CHANGE BULLETIN 06

F.G.A. No. 21003

ROOMS TO GO – OFFICE RENOVATION & EXPANSION

June 12, 2023

SHEET NUMBER
A2.01D

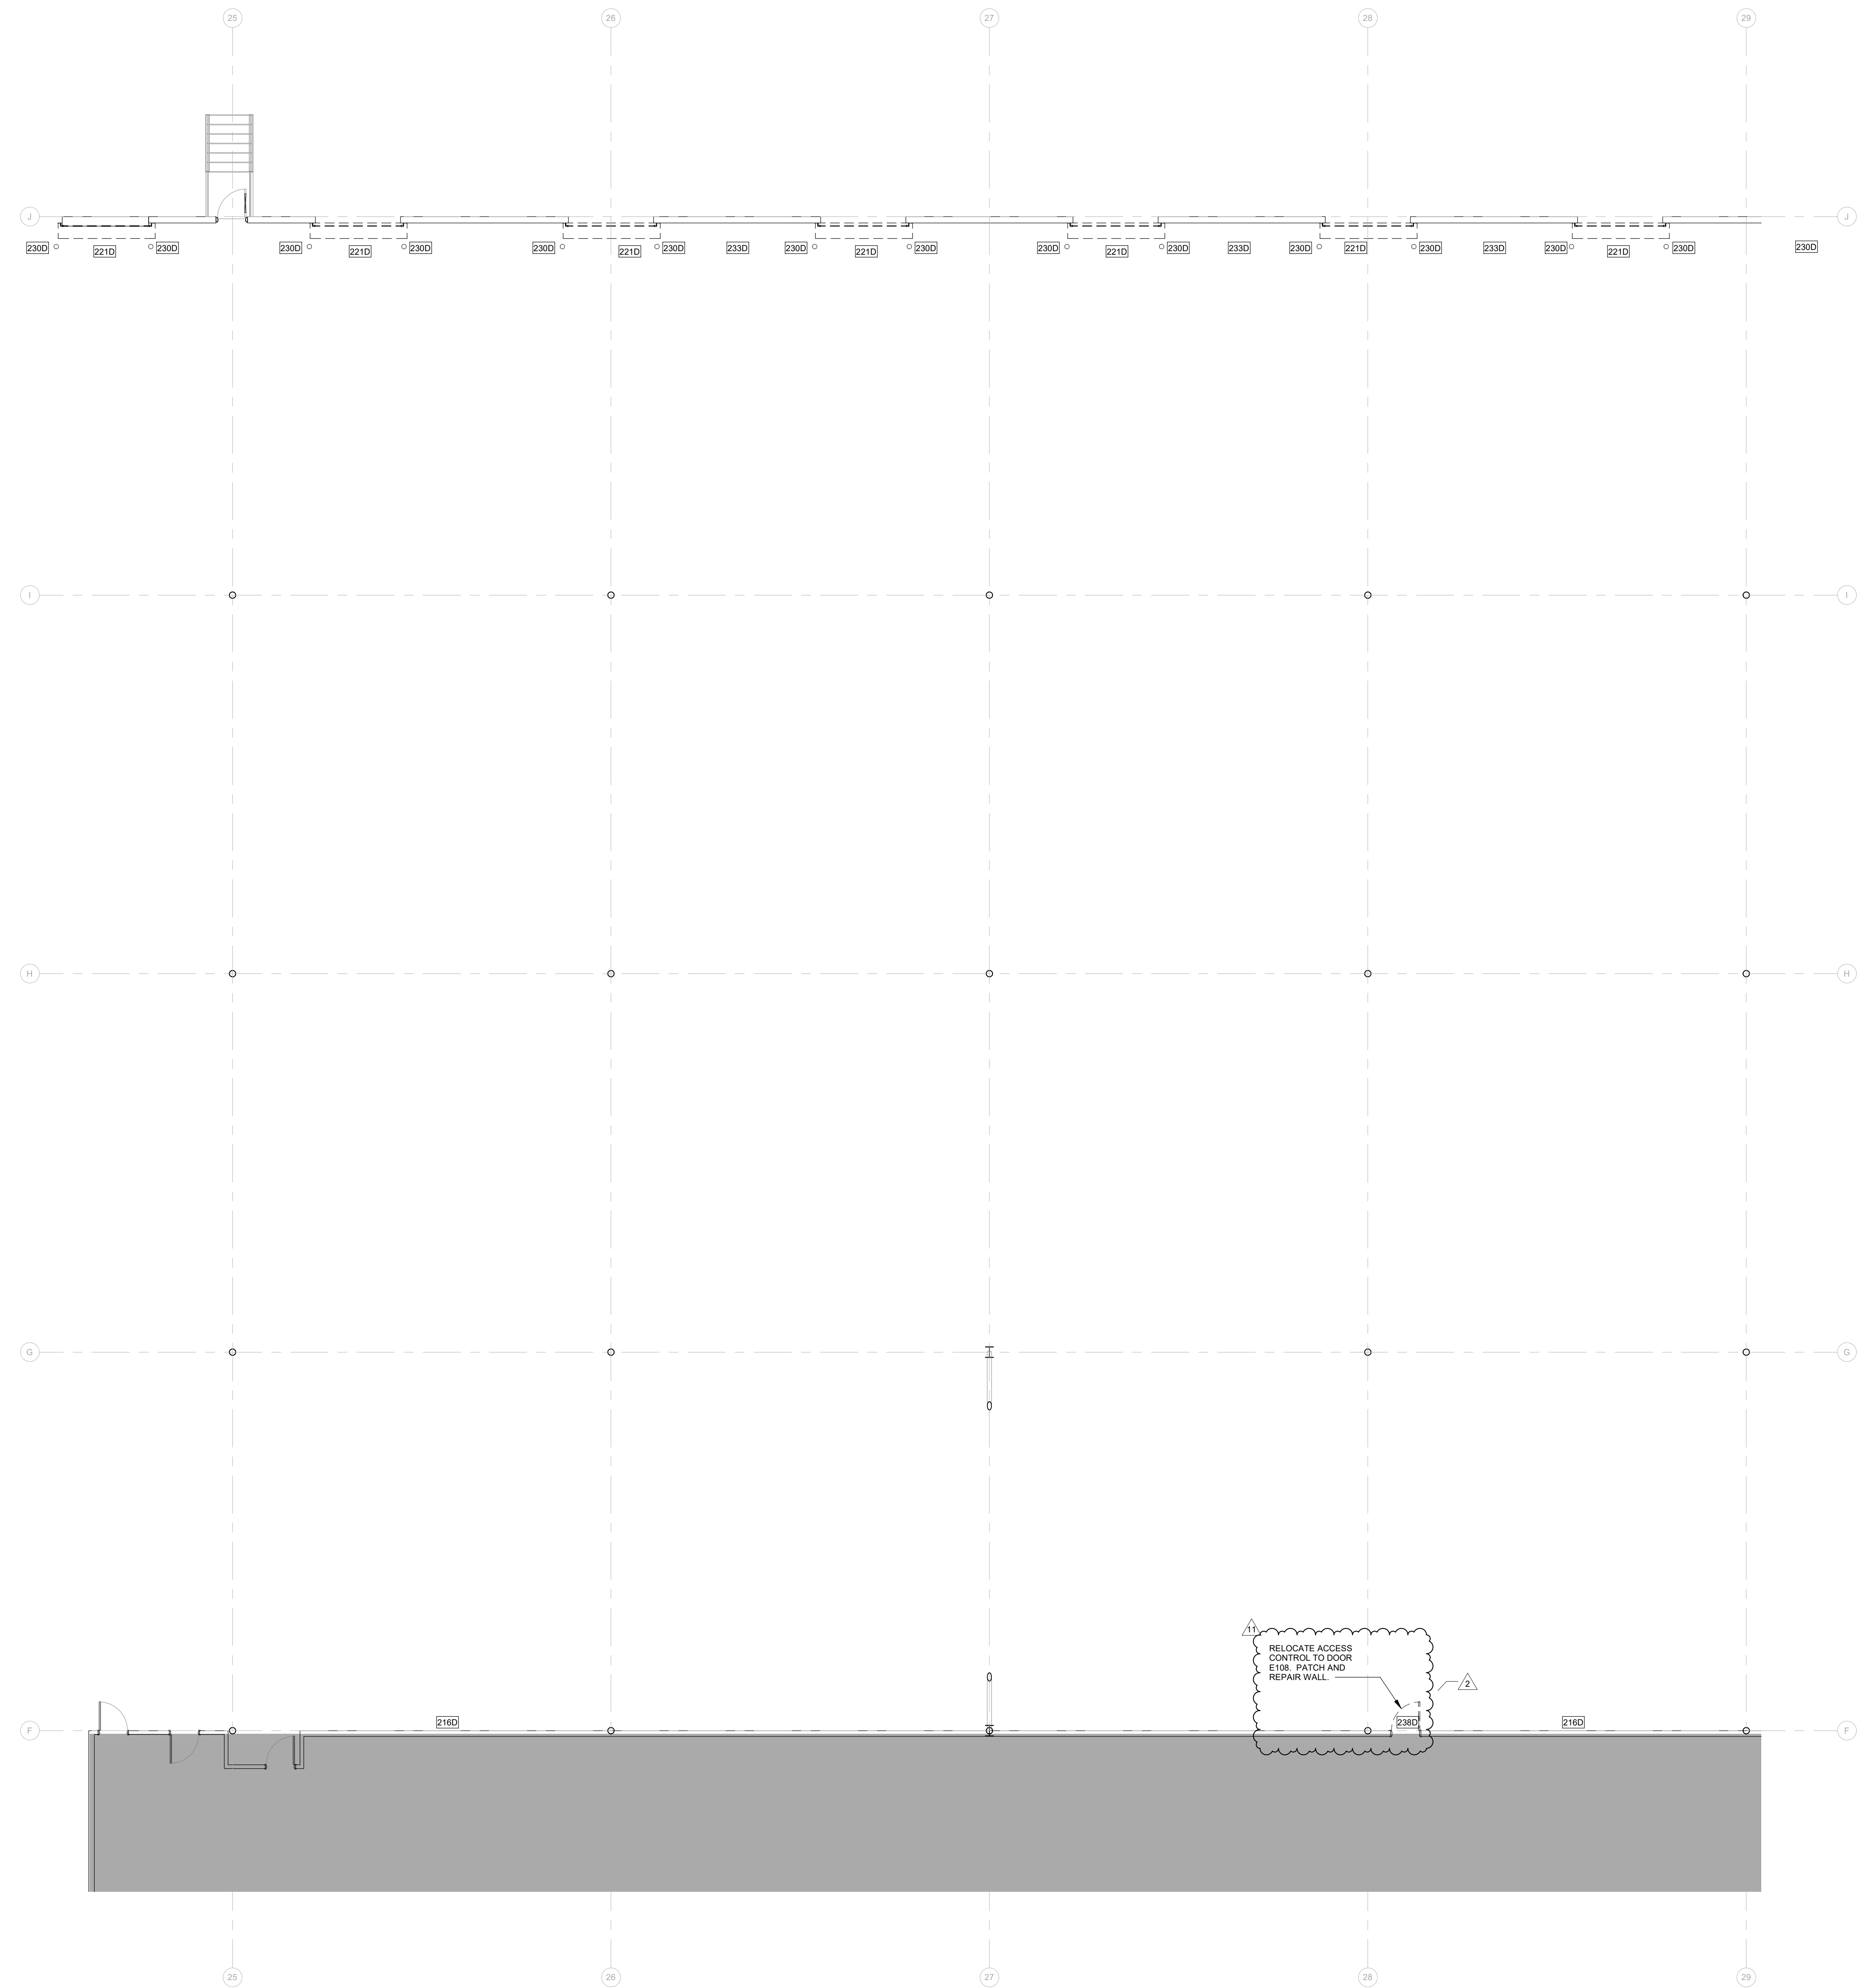
Item 1: Refer to Sheet A2.01D – Demolition Plan D

- Revise note 238D to “Remove existing door and frame. Patch and repair opening as required.”
- Add note “Relocate Access Control to door D148. Patch and repair wall.”

SHEET NUMBER
A2.01E

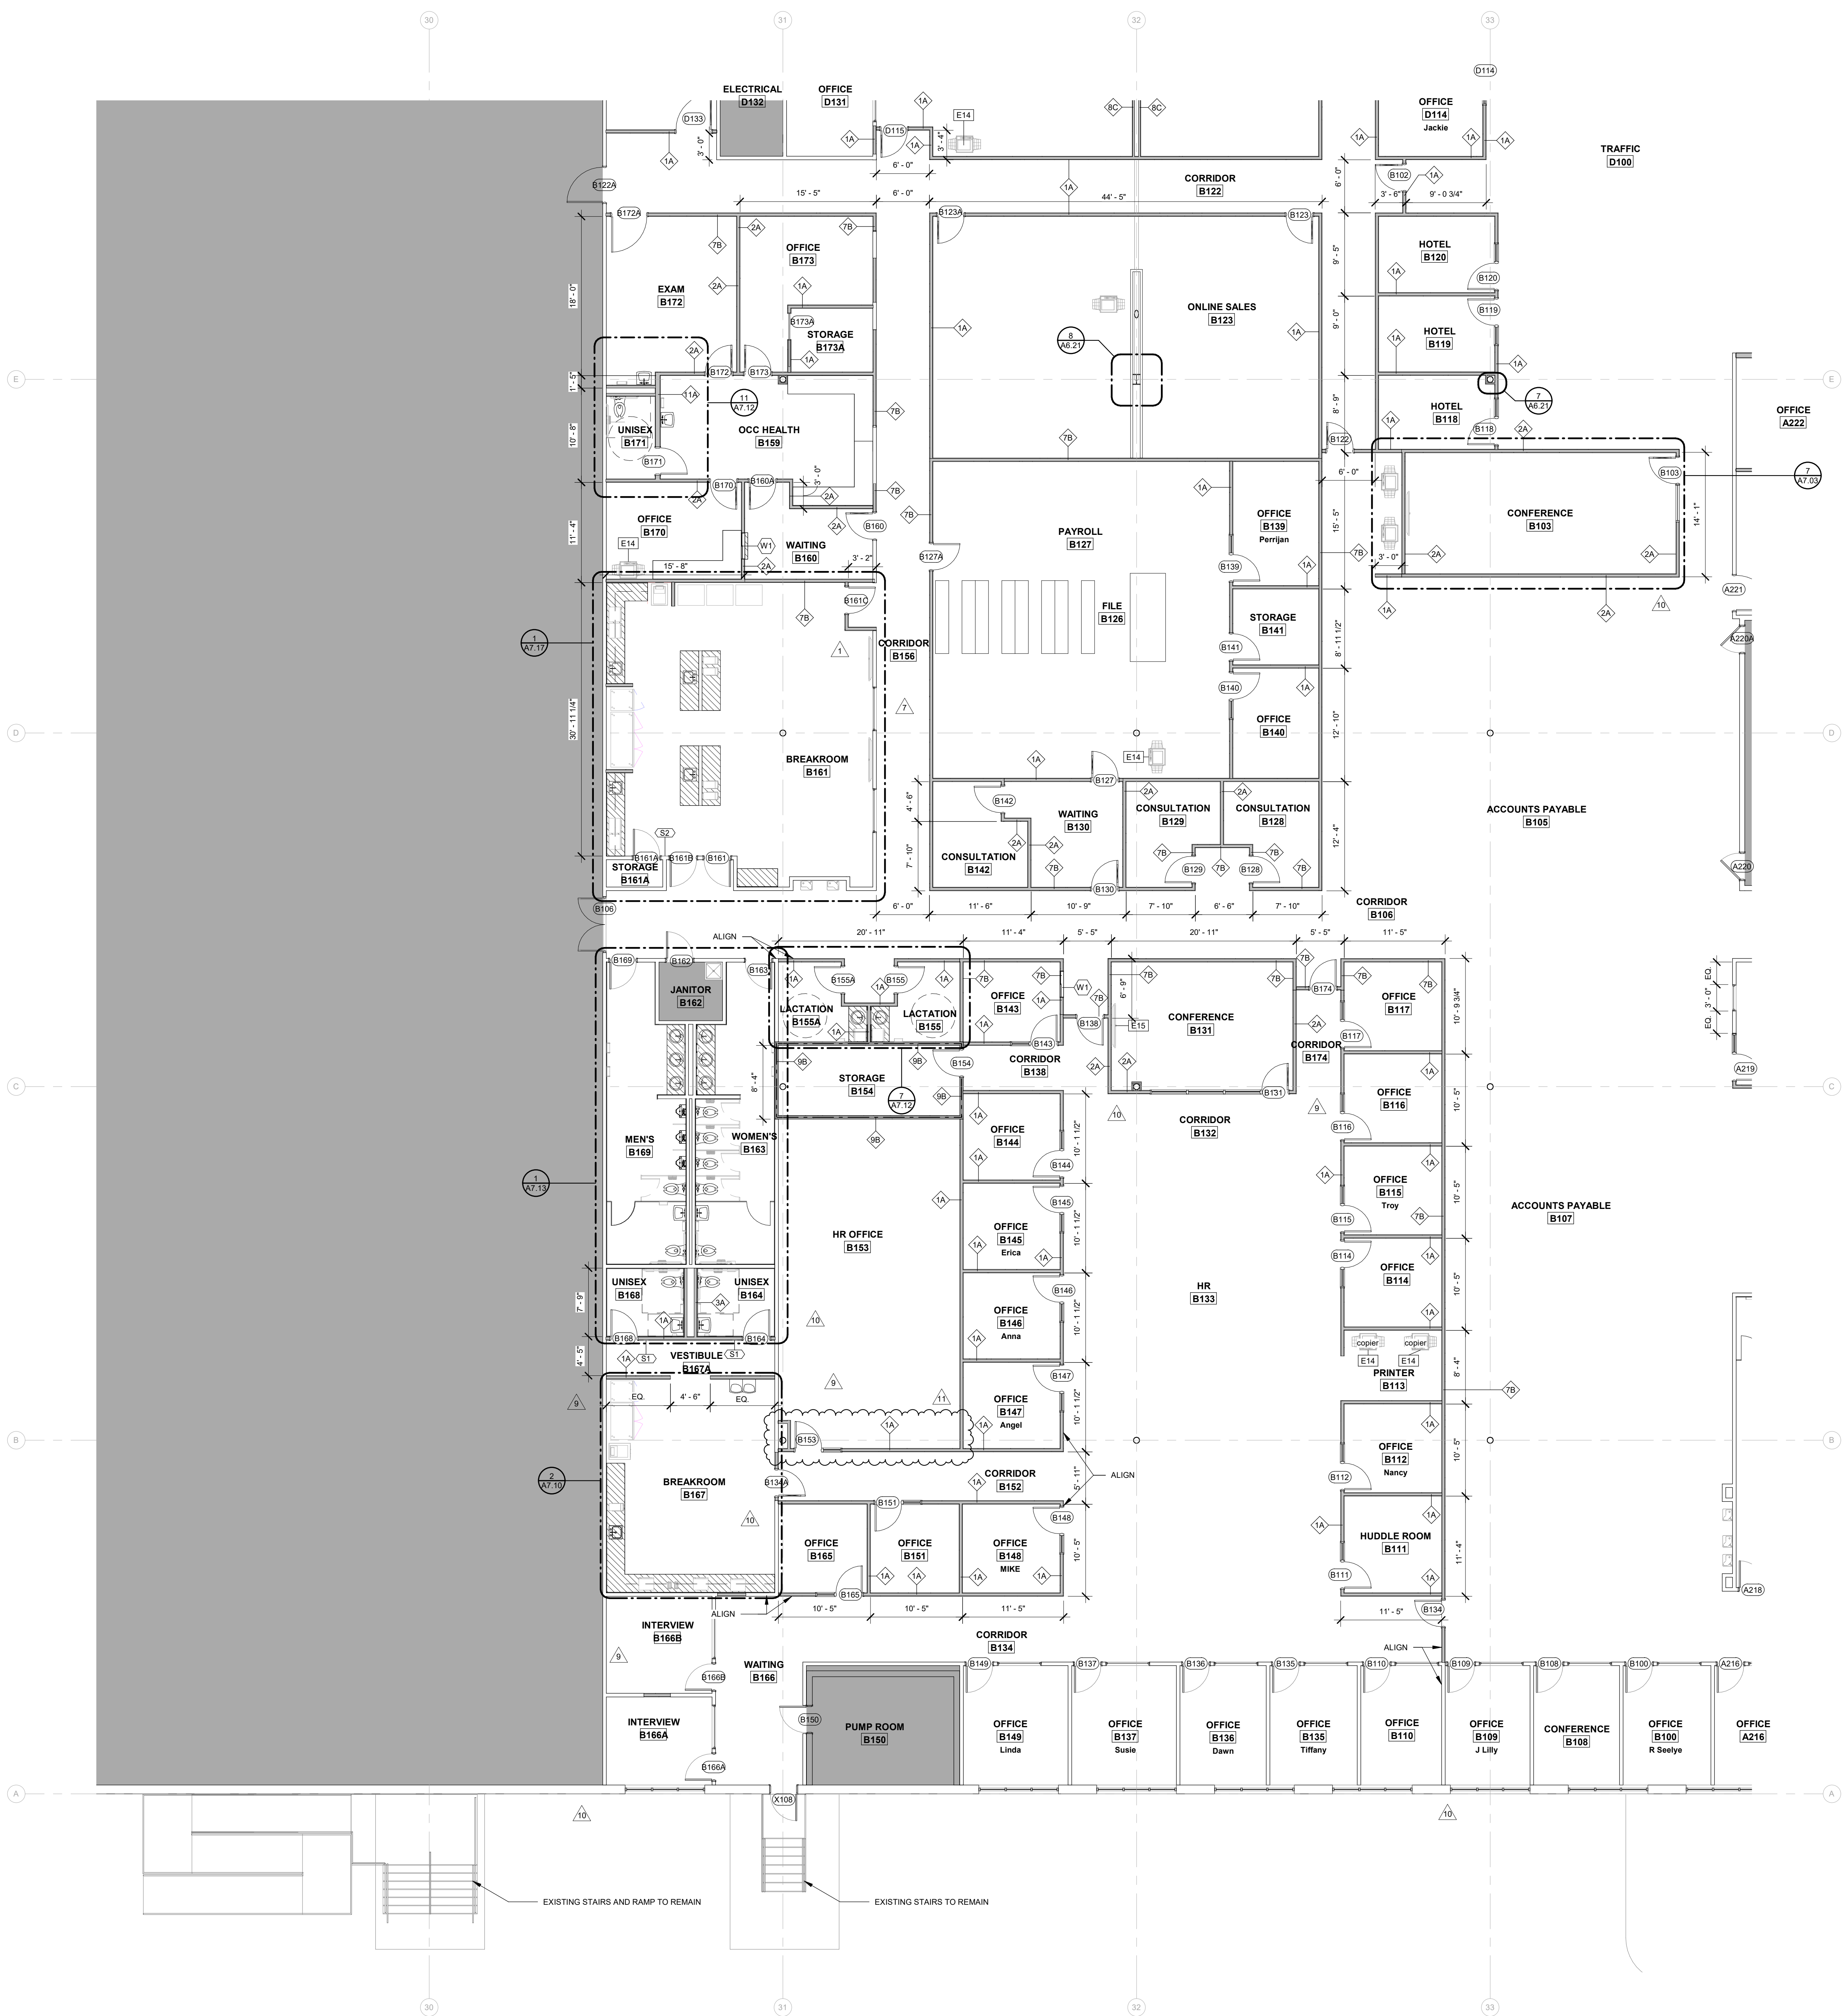
Item 2: Refer to Sheet A2.01E – Demolition Plan E

- Revise note 238D to “Remove existing door and frame. Patch and repair opening as required.”
- Add note “Relocate Access Control to door D148. Patch and repair wall.”

SHEET NUMBER
A2.10B

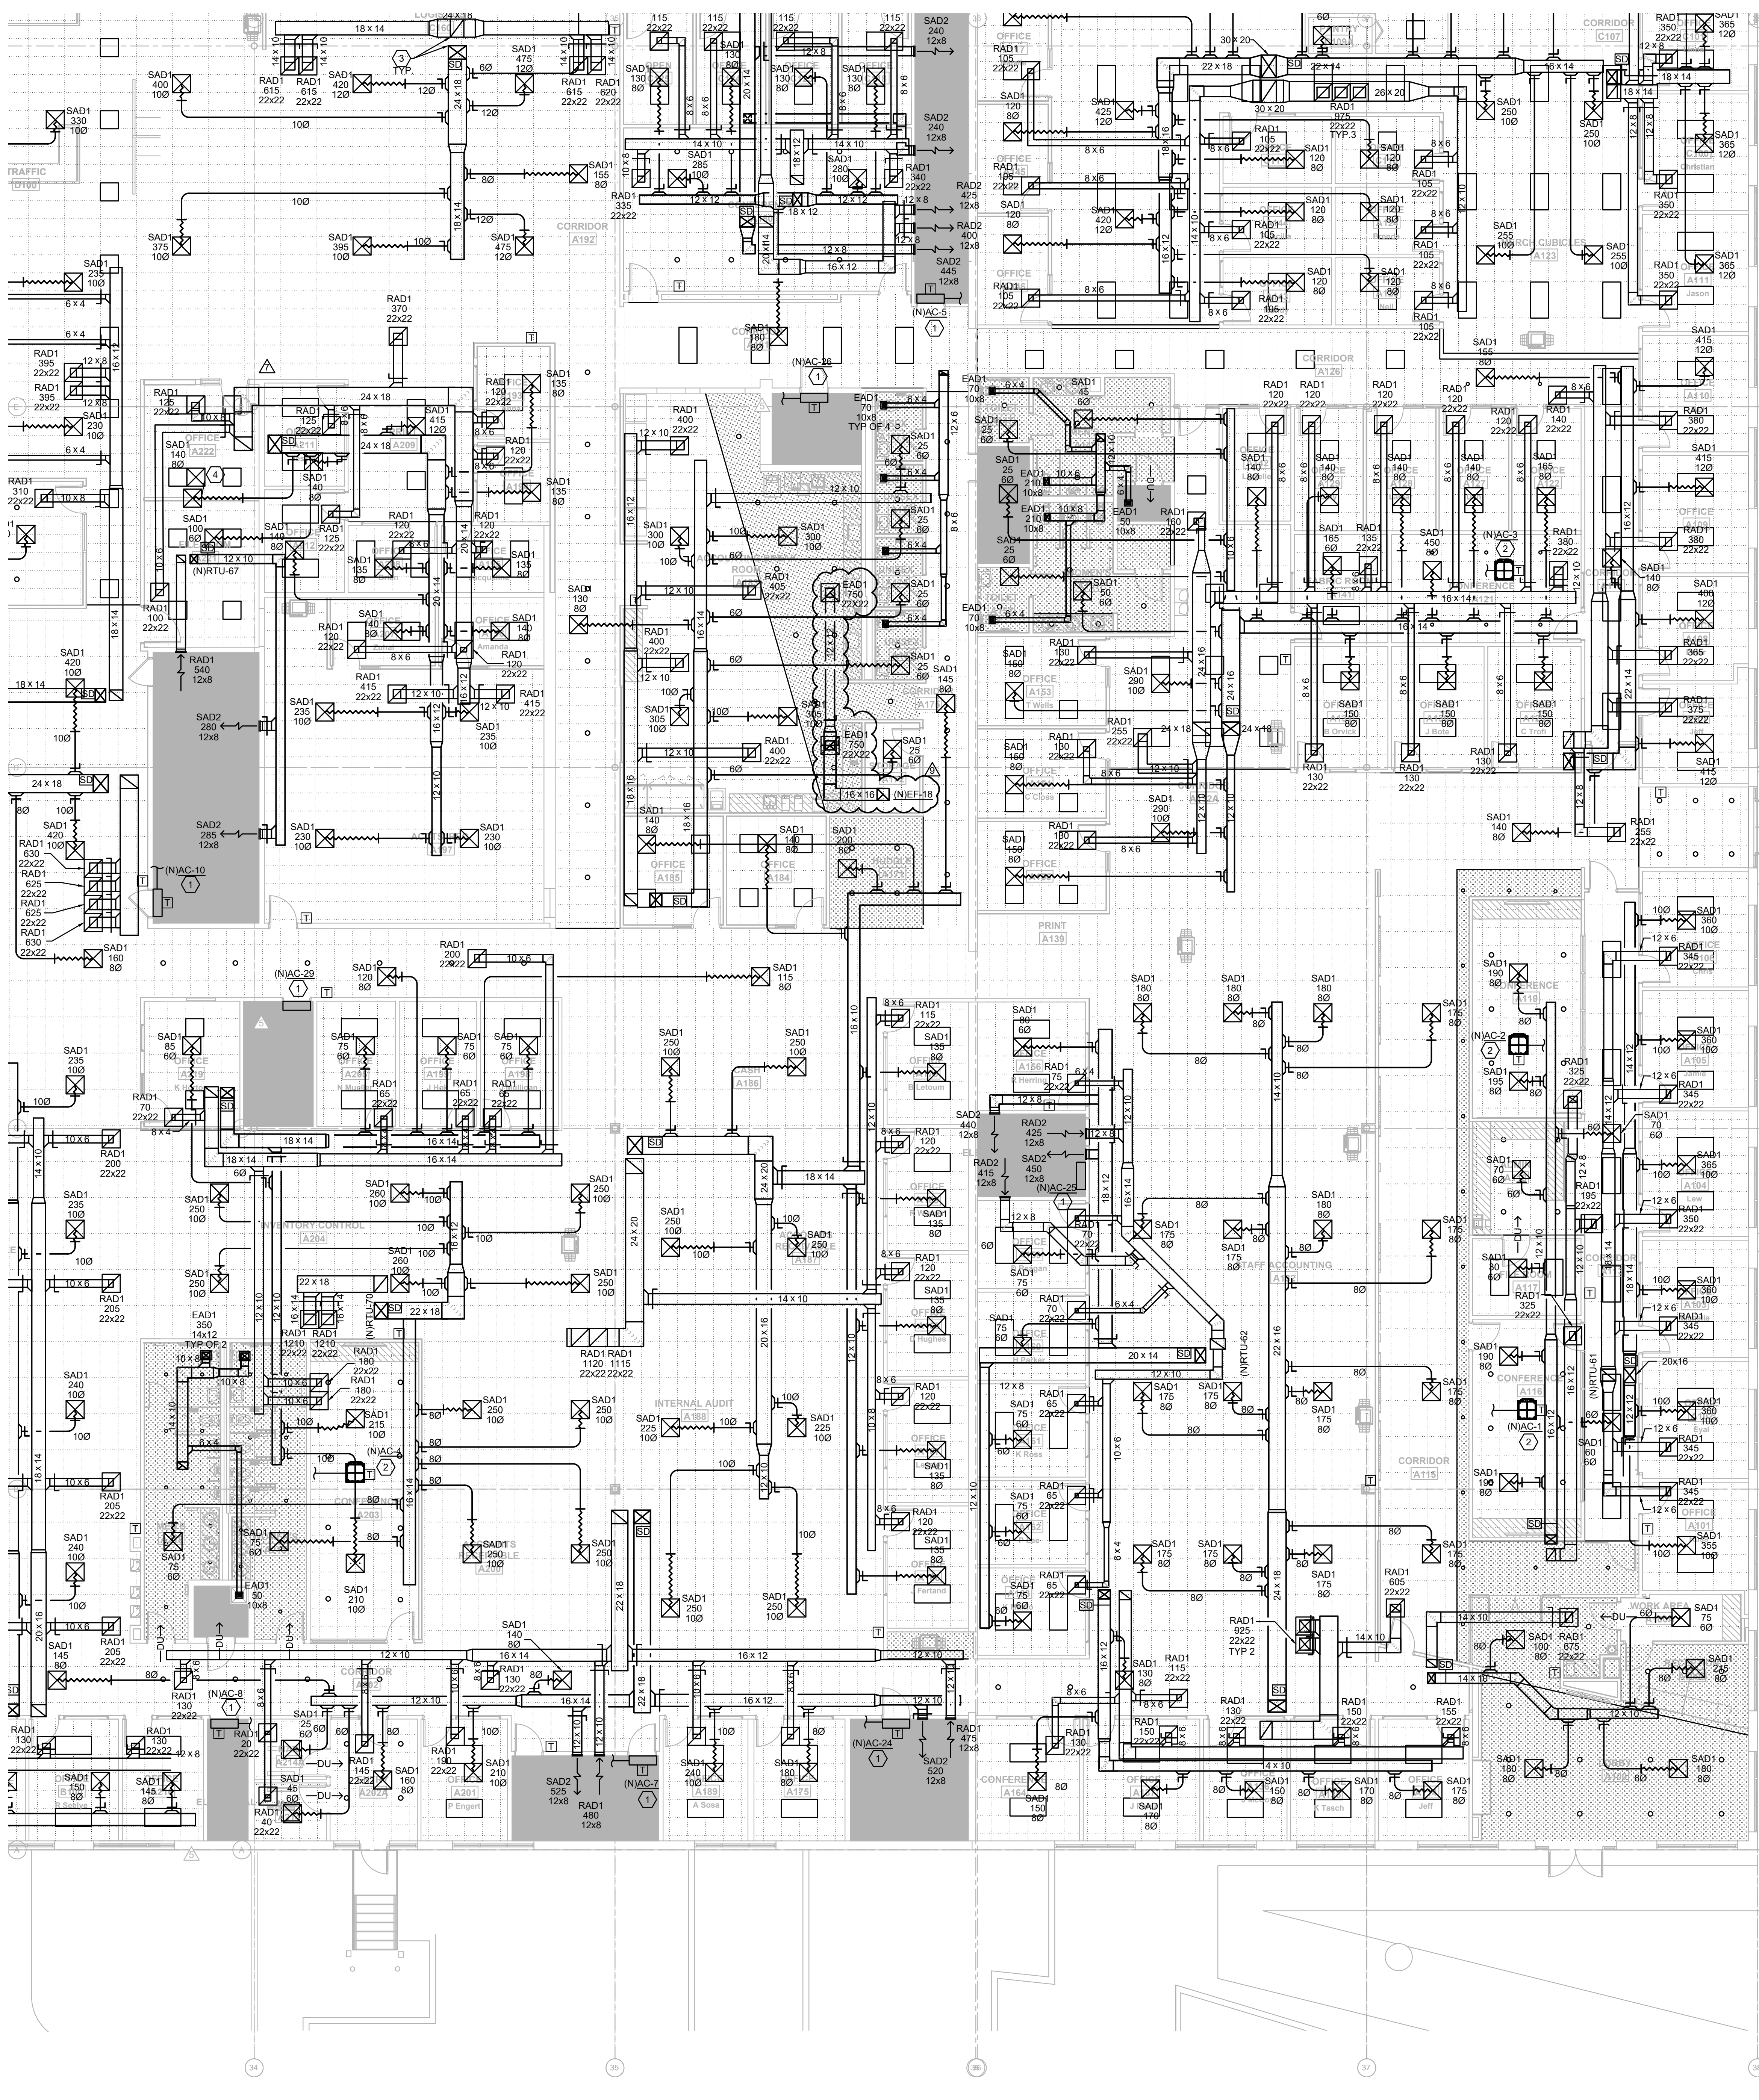
Item 3: Refer to Sheet A2.10B – Construction Plan B

- Add south wall back to HR Office B153.
- Add door B153 back to the south wall of HR Office B153.
